APPLICATION FOR SUBMITTAL OF POST-APPROVAL DOCUMENT

South El Monte High School Modernization

CCD-21

Project Reference: South El Monte High School Modernization Date: 11/21/2023

PLUMBING DEMOLITION ROOF PLAN - BLDG L

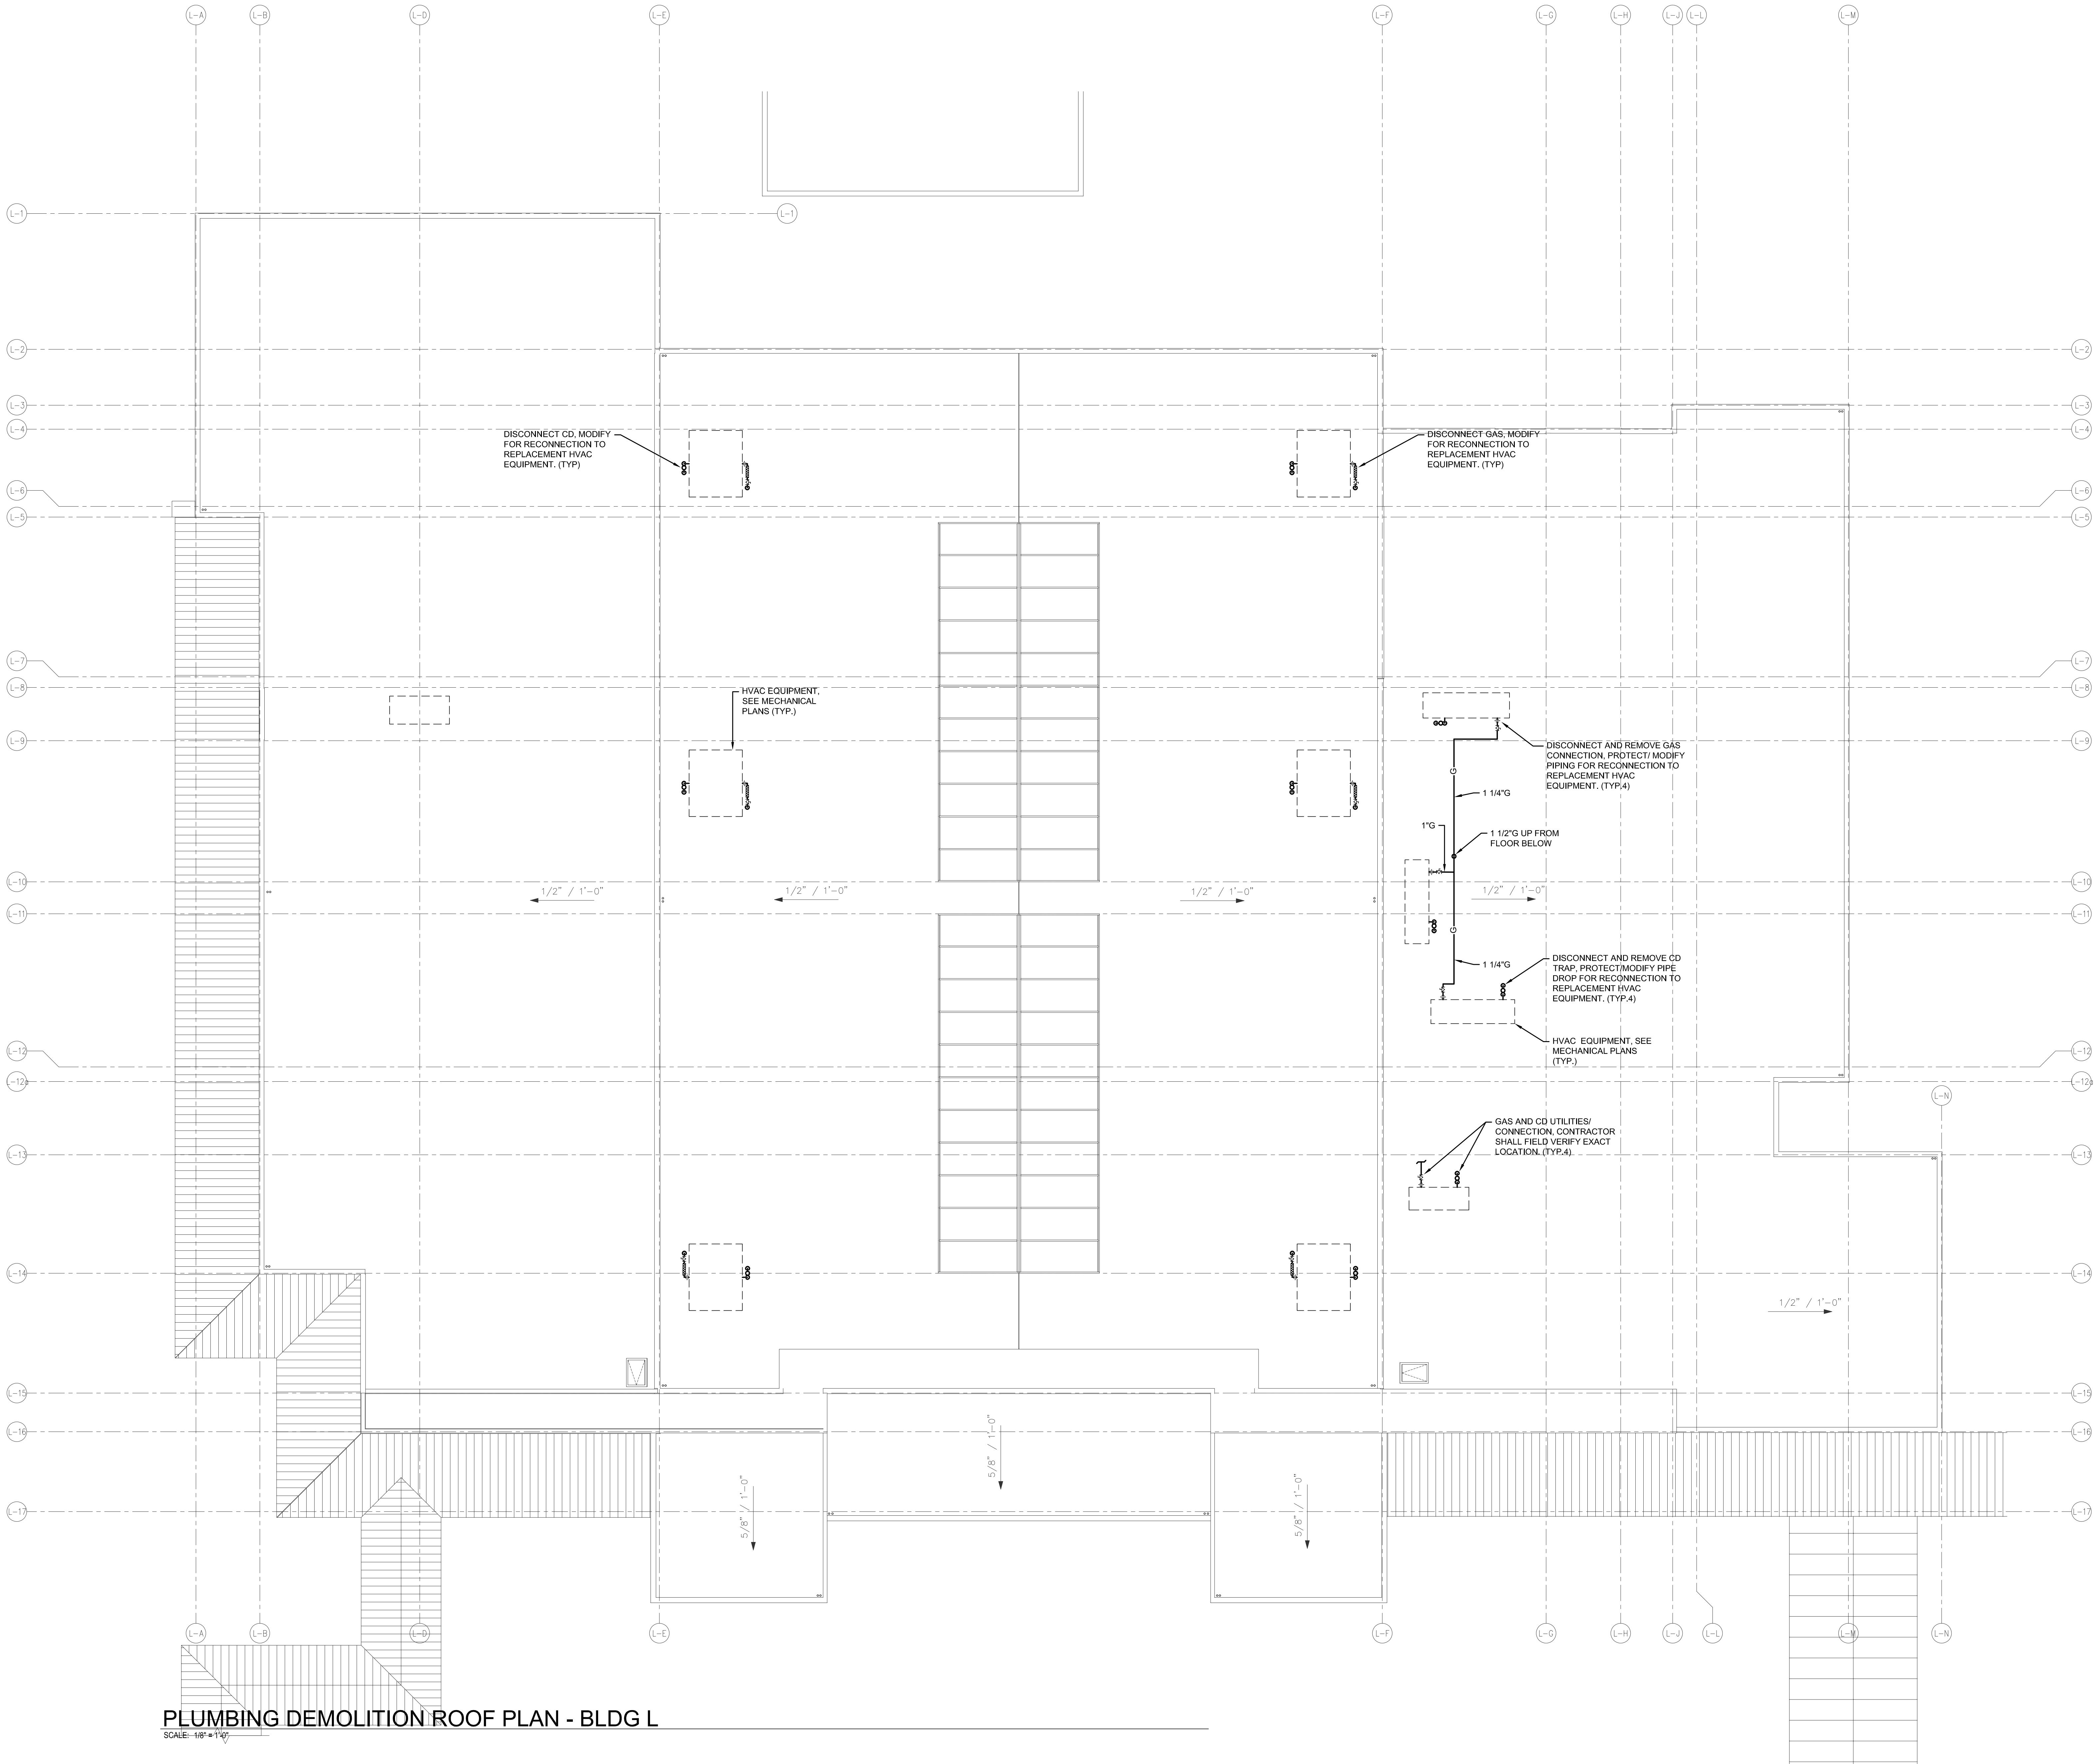
21.11.1. New sheet provided to identify the demolition of existing roof top units above the food service area.
- 21.12. SHEET P3.L1 – PLUMBING REMODEL ROOF PLAN – BLDG L**

PLUMBING REMODEL ROOF PLAN - BLDG L

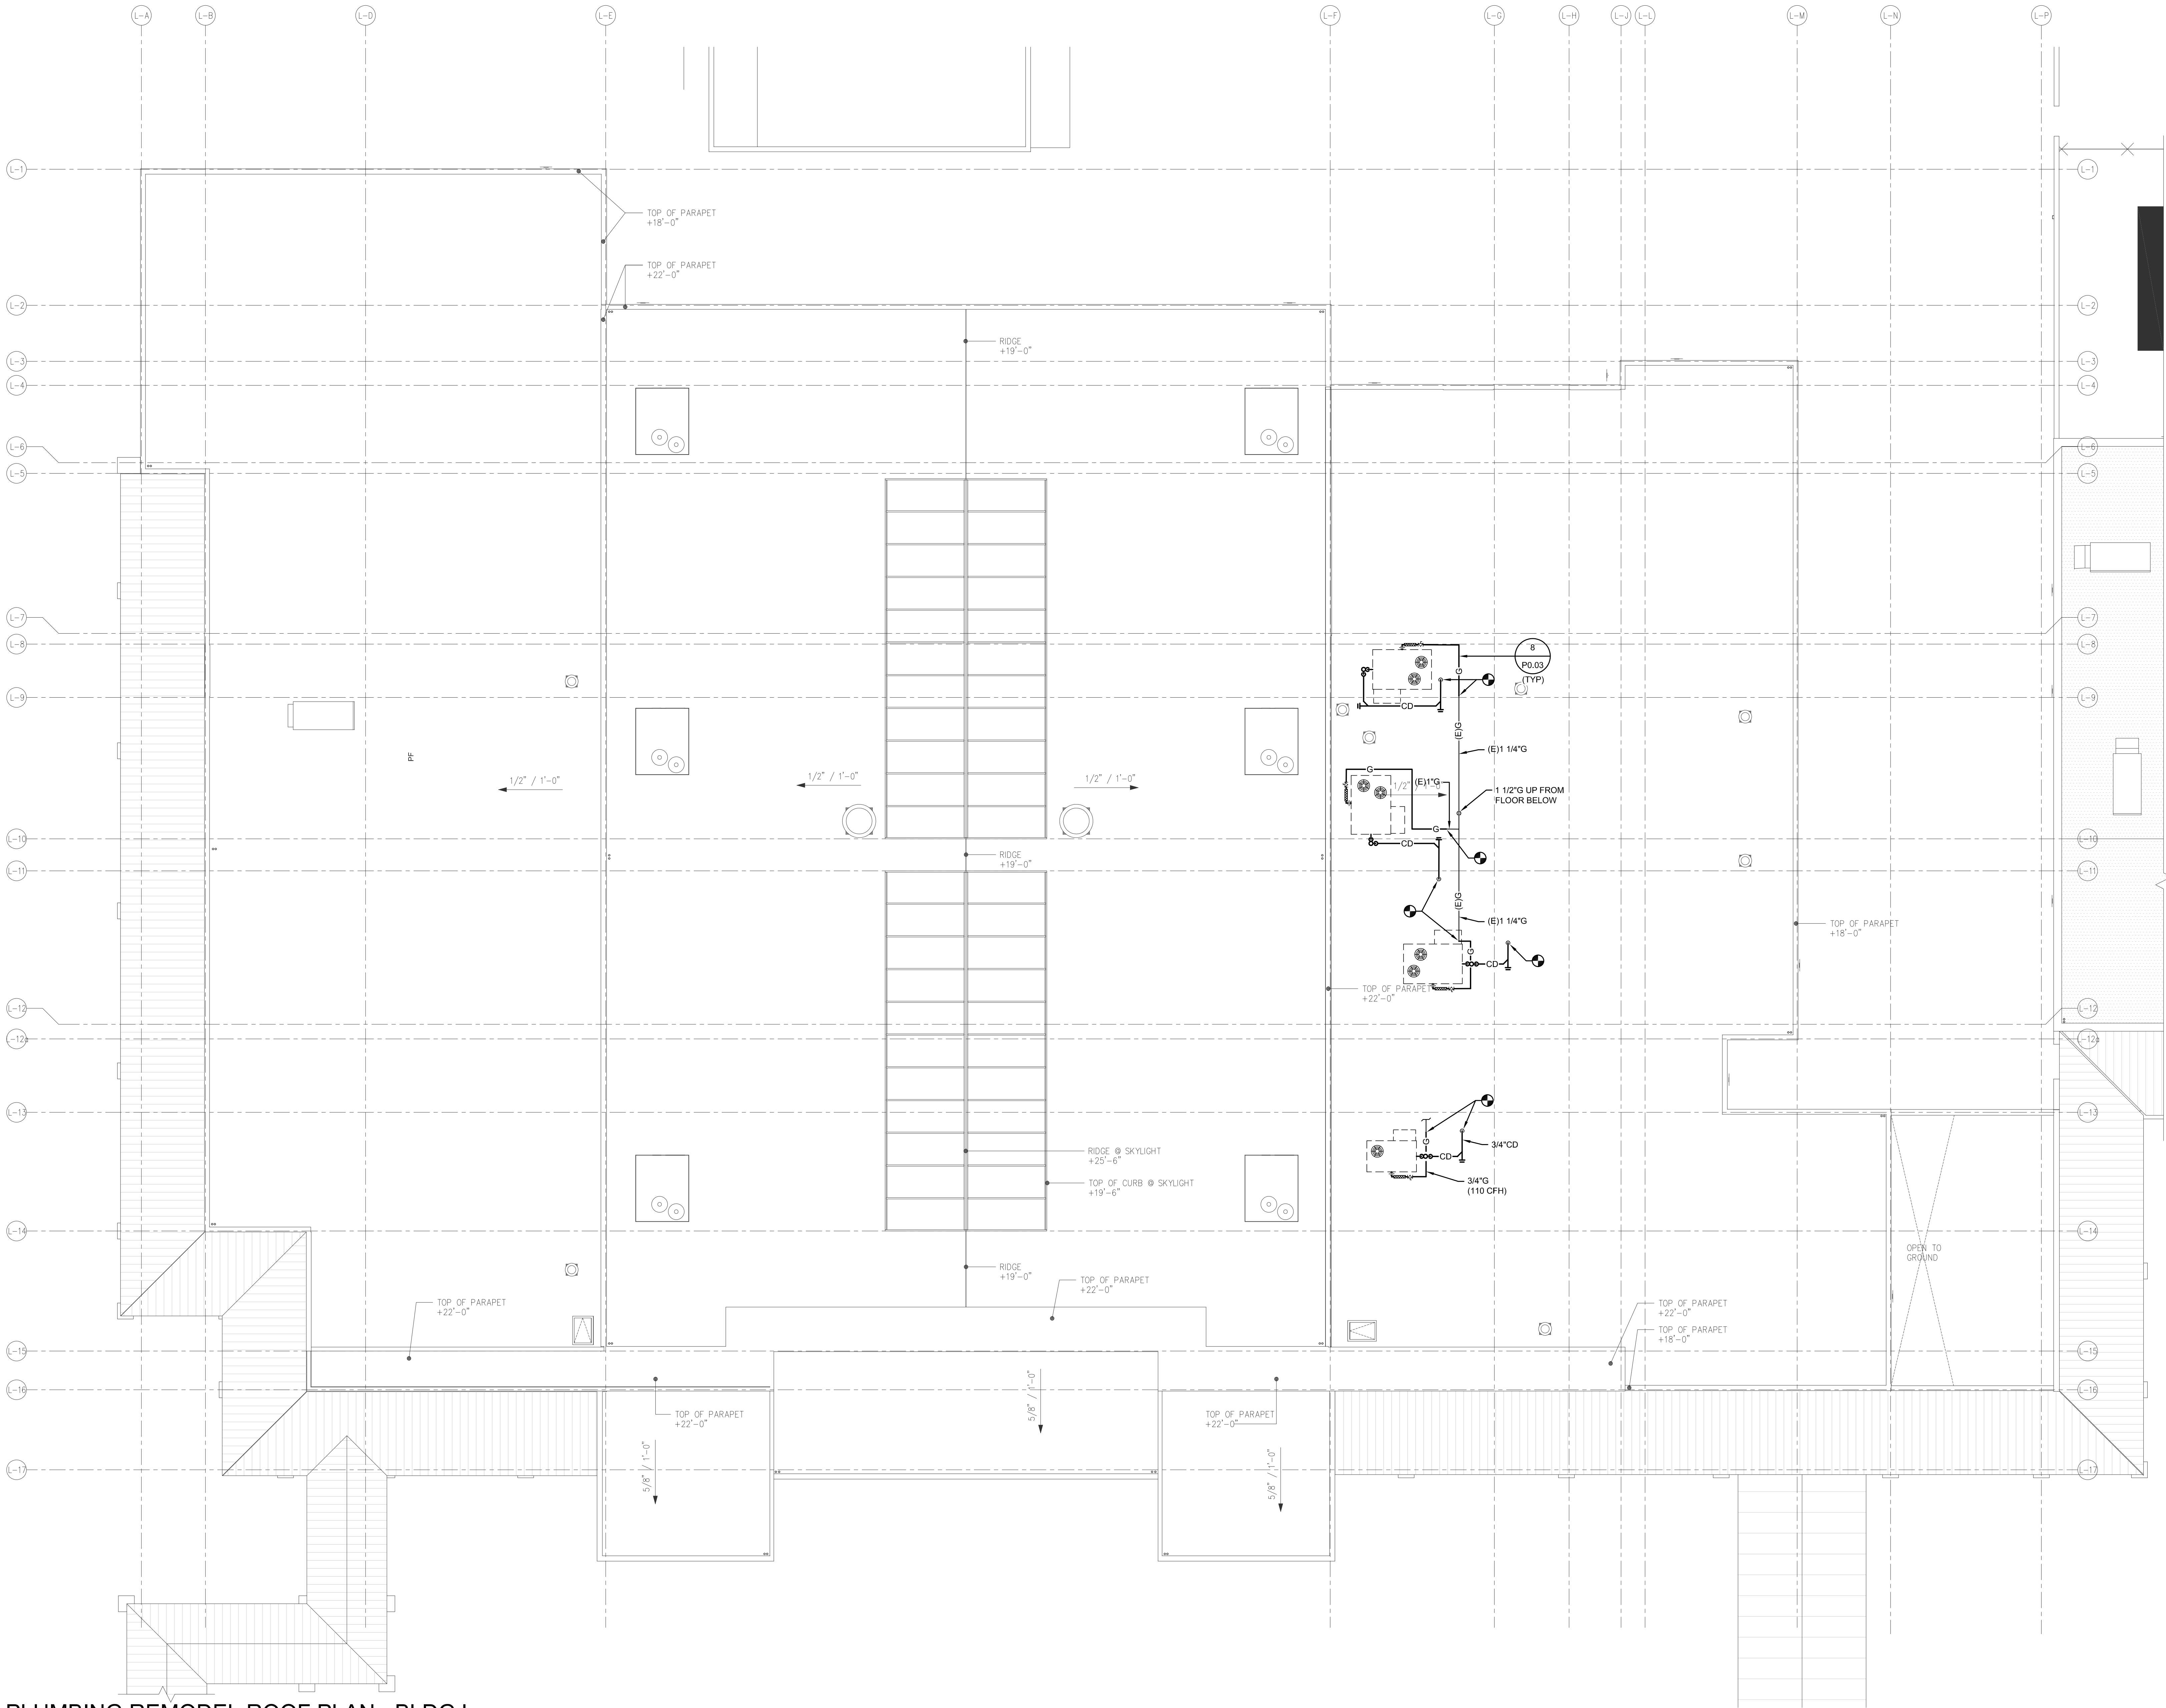
21.12.1. New sheet provided to identify gas and condensate piping for replacement HVAC roof top equipment above the existing food service area.
- 21.13. SHEET ED2.L2 – ELECTRICAL DEMOLITION ROOF PLAN – BLDG L**

ELECTRICAL DEMOLITION ROOF PLAN - BLDG L
SCALE: 1/8" = 1'-0"

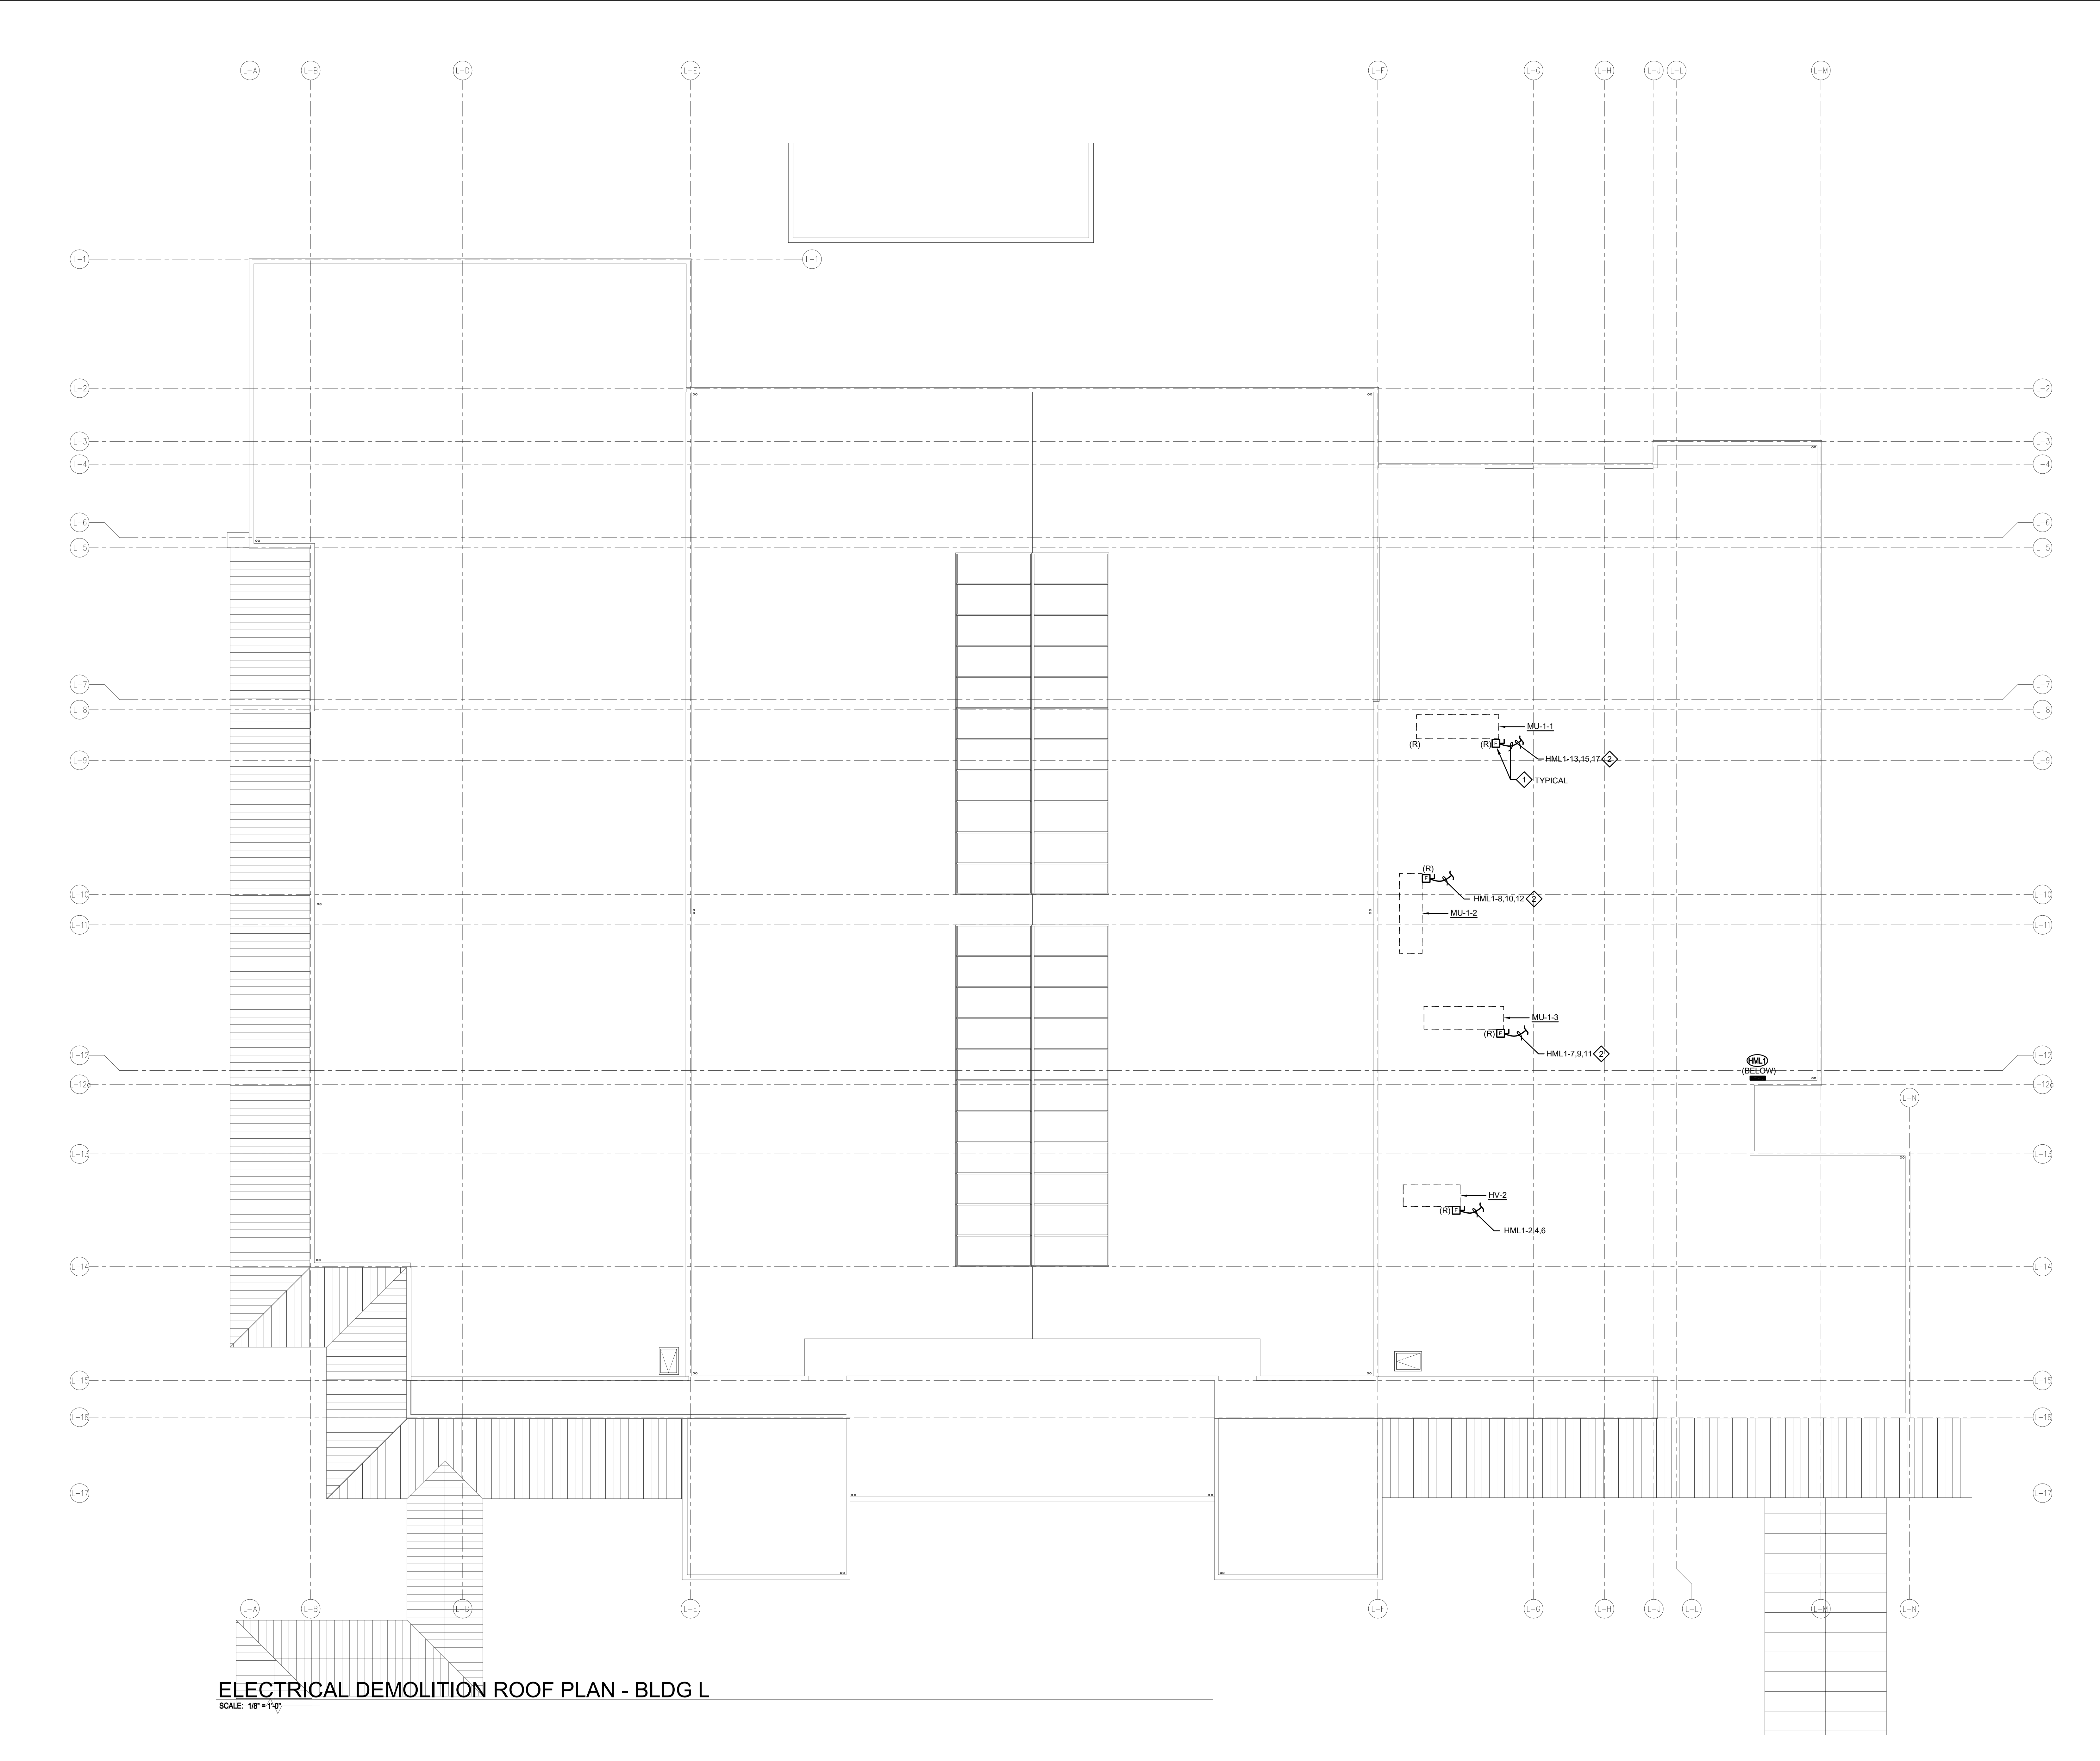
21.13.1. New sheet provided to identify electrical demolition for the existing roof top units to be removed above the existing food service area.
- 21.14. SHEET E2.L5 – ELECTRICAL ROOF PLAN – BLDG L**
